Subject: AP1000 Response to Request for Additional Information (SRP)

AP1000 TECHNICAL REPORT REVIEW

RAI Response Number: RAI-SRP14.3.2-CCIB-04

The details of the containment recirculation screen arrangements are provided in APP-GW-GLN-147, Revision 3 (AP1000 Containment Recirculation and IRWST Screen Design).

The image below is from APP-GW-GLN-147 and shows the plate configuration.

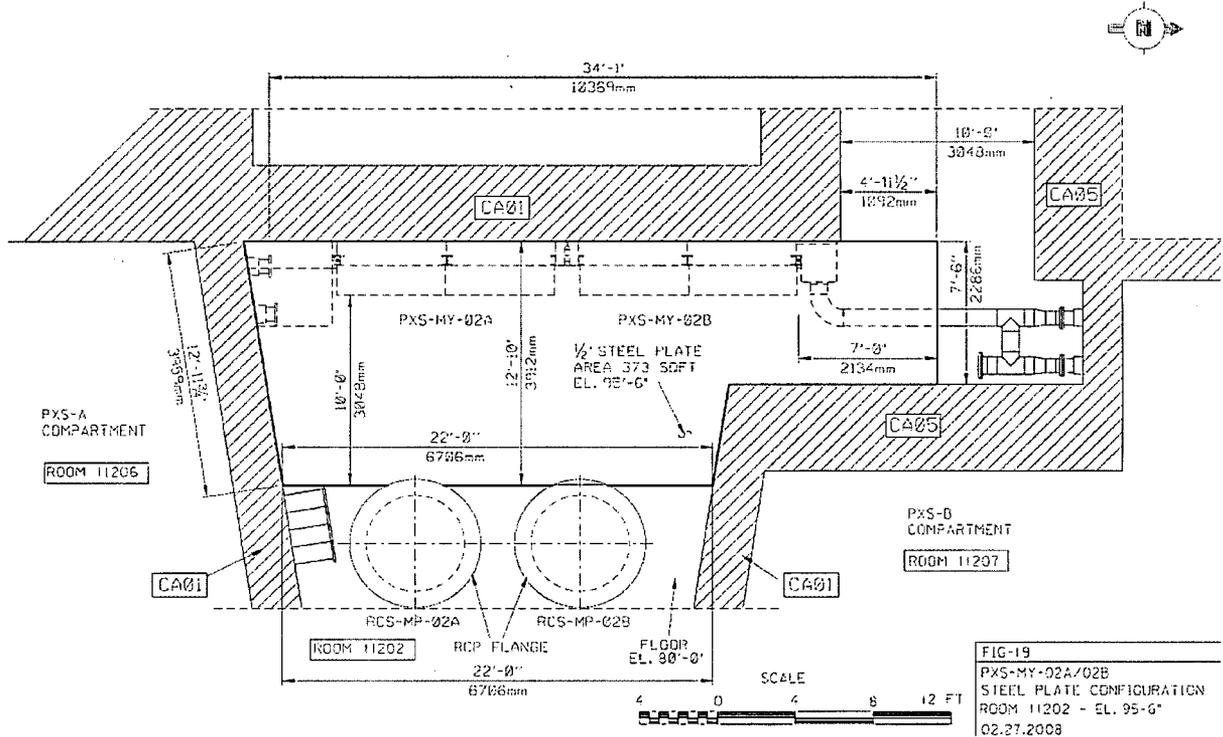
In ITAAC Table 2.2.3-4, for design commitment Item 8.c, ITA item vii states: "Inspections of the as-built components will be conducted for plates located above the containment recirculation screens." The AC item vii states that: "plates located above each containment recirculation screen are no more than 1 foot above the top of the screen and extend out at least 10 feet perpendicular to and at least 7 feet to the side of the screen surface."

The staff asks the applicant to explain the following: a) if there is to be one solid plate or if many individual plates are permitted above each recirculation screen, b) is there a minimum height of the plates above the top of the screens or can the plates be in contact with the screens, c) what is the required thickness of the plate or plates provided, d) the orientation of the plates to the screens since it is not clear as to what is perpendicular to the screens and what are the sides of the screens, and d) is the dimension of at least 7 feet to the side of the screen surface for only one side or two. The staff requests that the details provided in the applicant's explanation be incorporated into AC item vii.

- a) The configuration is to use many plates is to form a continuous / solid plate arrangement to cover each containment recirculation screen that provides a relatively lengthy path for fluid entry into the screen surface (inlet). A continuous plate configuration prevents having any paths that would allow debris to bypass the entire plate lengths specified and enter the recirculation screens, rather than either settling out on top of the plate or having the plate direct the flow past the ends of the plate (relatively far away from the screen surface inlet), to provide the anticipated settling distance prior to the flow reaching the screen surface.

- b) There is no minimum height of the plates above the top of the recirculation screens, so a minimum distance does not need to be specified in the ITAAC AC. The intent is that the plate be vertically close enough to the screen surface to effectively re-direct flow around the plate before entering the screen, to optimize debris settling. This precludes debris that may

be settling from anywhere above the screens from entering the screen surface. Placing the plates at any position within one foot above the top of the screens is acceptable for purposes of minimizing debris entry into the screen surface.

In the prescribed ITAAC AC arrangement, the plate must extend out at least 10 feet perpendicular to the screen face. This then requires that the flow must move back underneath the plate for this 10-foot flow path before entering the screen surface. This specified distance provides a sufficient settling distance for the containment recirculation flow entering the screen surface.

The plates above each recirculation screen are also required to extend out at least 7 feet to the side of the screen surface to accomplish the same flow path objective to increase the screen surface entry flow path as discussed in Item d), which maximizes debris settling before entry into the screen surface. The requirement for the plates to extend out to the sides applies to both sides of each screen, where practical. For example, the screen which is aligned nearest the south wall of the steam generator compartment (MY-Y02A) has a concrete wall within 7 feet of the side of the screen and, therefore, there is no need to have 7 feet of steel plate to that side of this screen. In this instance, the steel plate extends only to the concrete wall. The AC specifies that “vii) Plates located above each containment recirculation screen...and extend out at least 10 ft perpendicular to and at least 7 ft to the side of the screen surface.” This requirement applies to each side of the screen. The side of a screen is explained in the third paragraph in the discussion for Item d) above.
